UNITED STATES PATENT AND TRADEMARK OFFICE

10/718,836

Office Action Summary	Application No. 10/718,836	Applicant(s) ZILBERMAN ET AL.	
	Examiner JOSEPH STOKLOSA	Art Unit 3762

DETAILED ACTION

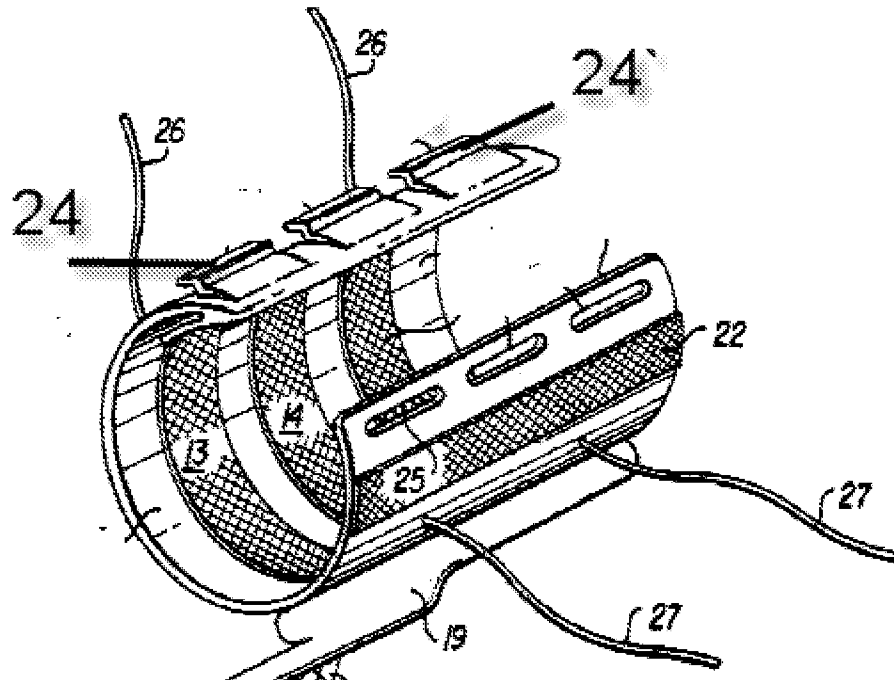
6. Maschino discloses the implantable device is substantially tubular as seen in Fig. 1A, element 13, with the holder being substantially semi-circular in cross section having a first and second end plate enclosing the hollow cavity in-between. Examiner considers the distal ends of the electrode structure to have end plates integrally formed with the hollow cavity holder for securing the electrodes to the holder structure.

9. With regard to Claim 10, Examiner considers Maschino to disclose two separate sets of wings.

11. Examiner has relabeled in the figure above to better illustrate what is considered the first and second sets of wings. Wing 24 substantially connects the first electrode, 13, to the holder member and the neuromuscular tissue; conversely, wing member 24' substantially connects electrode 15 to the holder member and neuromuscular tissue. This can also be seen in alternate embodiment shown in Fig. 3.
